Answer for reviewers' comments

Respond for RC1:

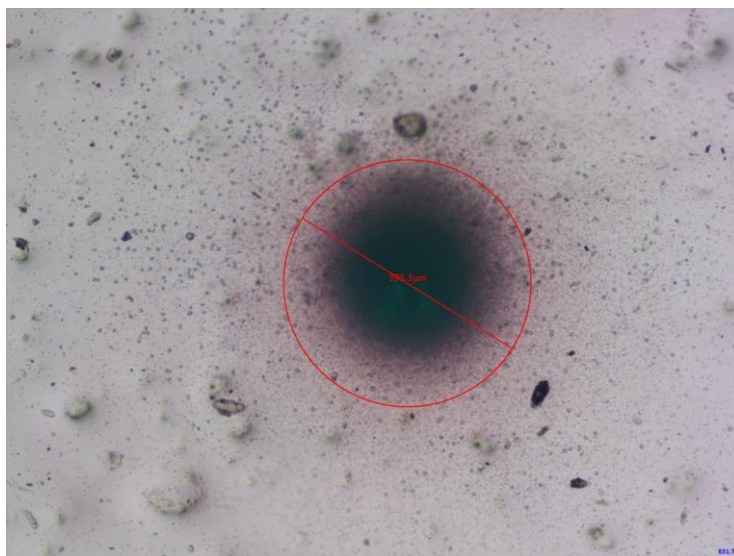
Q12: Line 179. For this new optical system, do the particle detection beams pass through focusing or shaping optics? State the approx. laser beam waists where the particles intersect the laser beams.

A12: In the novel optical system, the laser beam is shaped by optical components to form a rectangular spot of $600\text{ }\mu\text{m} \times 30\text{ }\mu\text{m}$. In this experiment, the particle beam width was measured at a position 110 mm downstream from the lens exit, which exceeds the distance between the lens and the beam profiling laser (67 mm), indicating that the actual particle beam width at the beam profiling laser position is narrower. Analysis of the microscope-captured distribution image of mixed particles (300 nm, 740 nm, 1 μm , 2 μm , 5 μm) at the beam profiling laser position (as shown in the figure below) reveals that the particle beam width at this location is smaller than the laser beam waist.
